COMMUNITY DEVELOPMENT DEPARTMENT REPORT

HEARING DATE: 12/5/2024

APPLICANT: Brighton Corporation

SUBJECT: [H-2024-0037](#)
Pollard North - PP, RZ

F. Common Driveway Exhibit

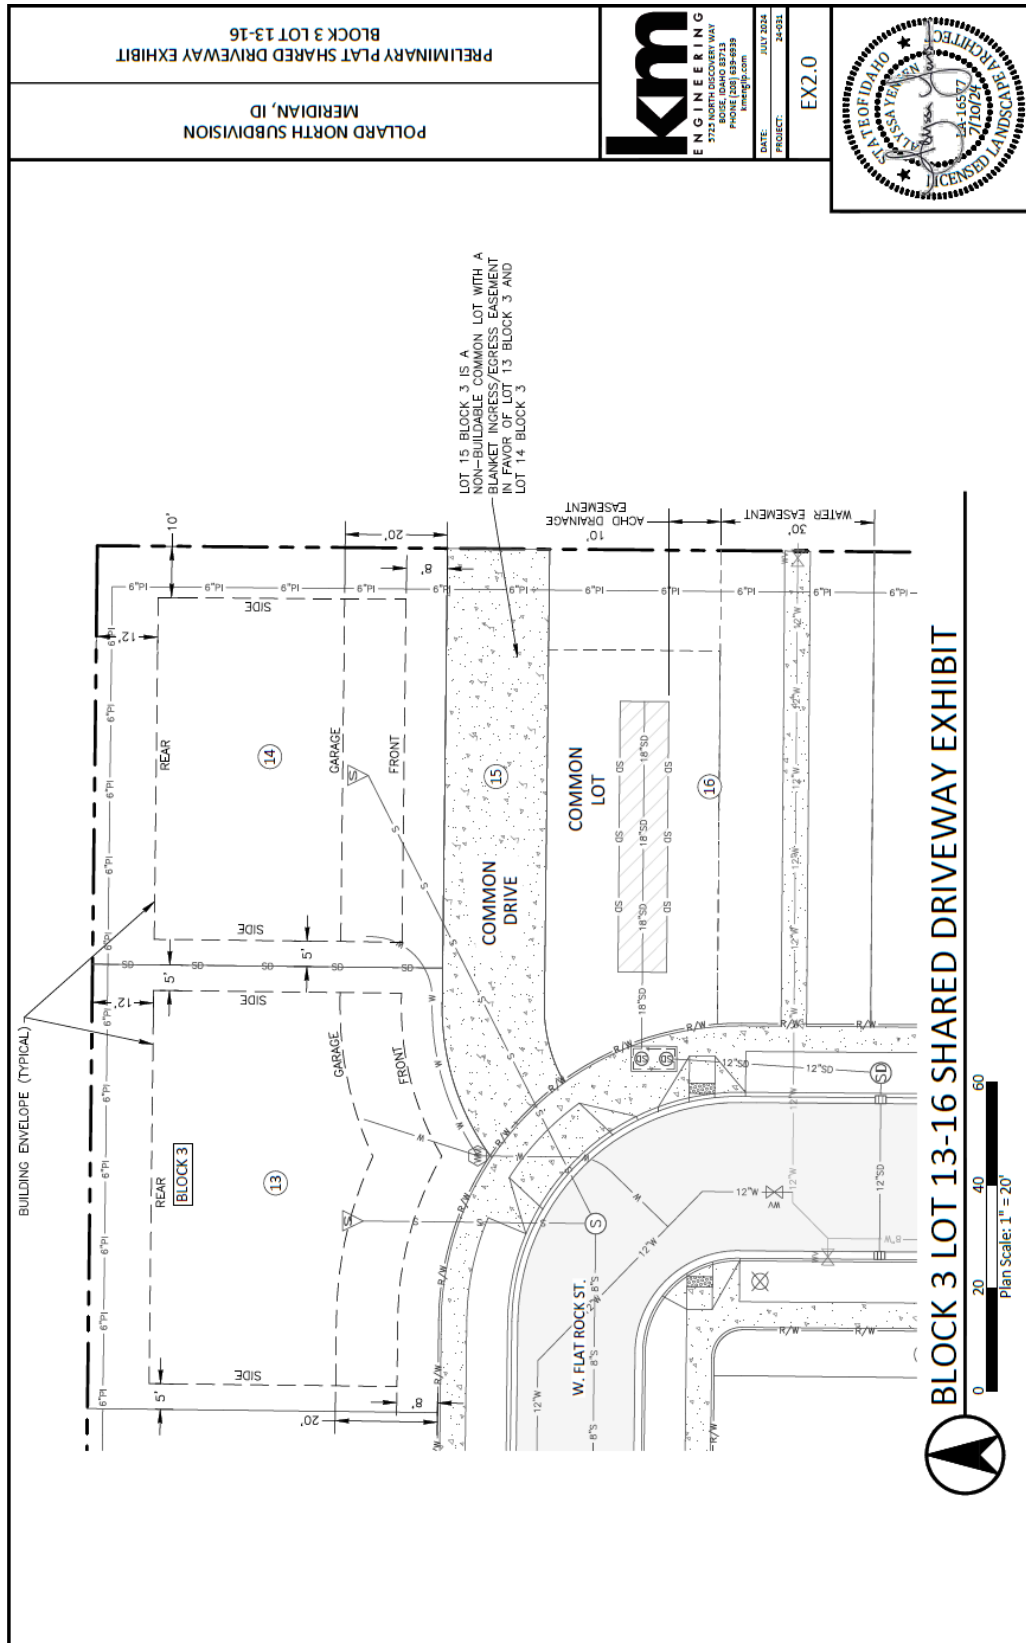
Common driveways: Common driveways are required to comply with the standards listed in UDC 11-6C-3D. One (1) common driveway is proposed on Lot 15, Block 3 for access to Lots 13 and 14. A common driveway exhibit is included in Section VII.F that demonstrates compliance with the standards listed in UDC 11-6C-3D. **Perpetual ingress/egress shall be required either by a recorded easement or as a note on a recorded final plat. The easement or plat note shall include a requirement for maintenance of a paved surface capable of supporting fire vehicles and equipment. Solid fencing adjacent to common driveways is prohibited, unless separated by a minimum five-foot wide landscaped buffer planted with shrubs, lawn or other vegetative groundcover – if fencing is proposed along the south side of Lot 15, Block 3, a 5-foot wide buffer should be provided.**

- iv. If solid fencing is proposed along the south side of Lot 15, Block 3, a 5-foot wide buffer should be provided planted with shrubs, lawn or other vegetative groundcover as set forth in UDC 11-6C-3D.5. The plat should be adjusted accordingly.

4. The common driveway shall be constructed in accord with the standards listed in UDC 11-6C-3D and per the common driveway exhibit in Section VII.F.
5. Perpetual ingress/egress shall be required for the common driveway either by a recorded easement or as a note on a recorded final plat as set forth in UDC 11-6C-3D. The easement or plat note shall include a requirement for maintenance of a paved surface capable of supporting fire vehicles and equipment.

H. Open Space & Site Amenity Exhibits (dated: July 2024)

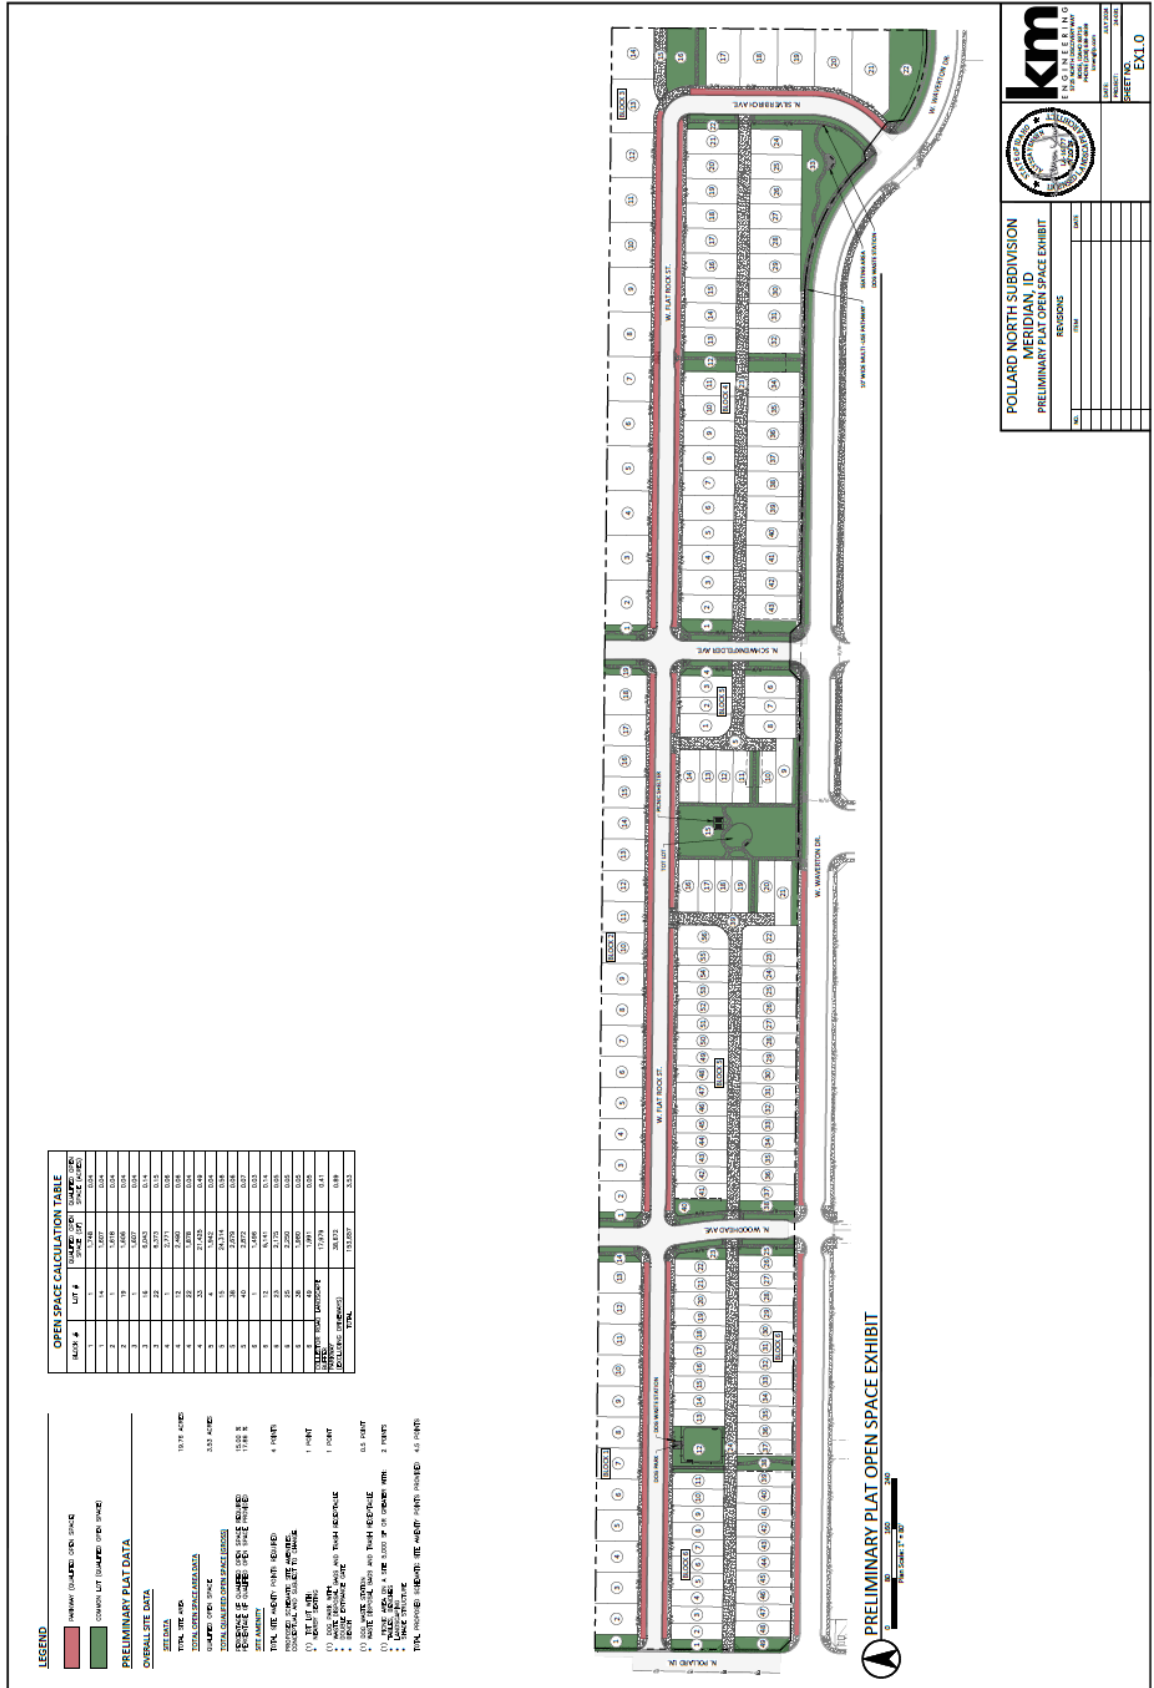
Amenities totaling a minimum of four (4) points are required to be provided based on the area of the development (i.e. 19.76-acres). Site amenities totaling 4.5 points (pts.) are proposed from the Quality of Life and Recreation Activity categories as shown on the exhibit in Section VII.I as follows:

- Quality of Life: a small dog park (3,900 s.f.) with a waste station (1.5 pts.) and a picnic area on a site 5,000 s.f. or greater in size (2 pts.).

The dog park is required to have bags for dog waste disposal, a double entrance gate, bench(es) and fencing to enclose the area and to secure the open space for an off-leash dog park as set forth in UDC 11-3G-4C.9. The dog park also counts toward the required common open space.

The picnic area is required to include tables, benches, landscaping and a structure for shade, as set forth in UDC 11-3G-4C.5.

- Recreation Activity Area: a tot lot (1 pt.)

Per UDC 11-3G-4D.3, the tot lot is required to have commercial grade play equipment scaled and designed for the use and safety of younger children; benches for seating shall be provided nearby.

6. Submit a detail of the dog park that demonstrates compliance with the standards listed in UDC 11-3G-4C.9, which require bags for dog waste disposal, a double entrance gate, bench(es), and fencing to enclose the area and secured open space for an off-leash dog park.

7. Submit a detail of the tot lot that demonstrates compliance with the standards listed in UDC 11-3G-4D.3, which require commercial grade play equipment scaled and designed for the use and safety of younger children with benches for seating nearby.

8. Submit a detail of the picnic area that demonstrates compliance with the standards listed in UDC 11-3G-4C.5, which require the area to include tables, benches, landscaping and a structure for shade.
